PRODUCT UPDATE

- **C2G54463** - 4-Port USB-A Hub with 5V 2A Power Supply

MODEL COMPARISON PREVIOUS VS. UPDATED DESIGN

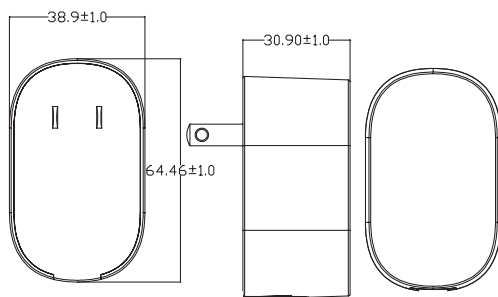
1. The **power supply dimensions** have changed from 2.37in x 1.46in x 1.06in (LxWxH) to 2.54in x 1.53in x 1.21in (LxWxH).
2. The **power supply cord length** has changed from 46.5in to 47in.
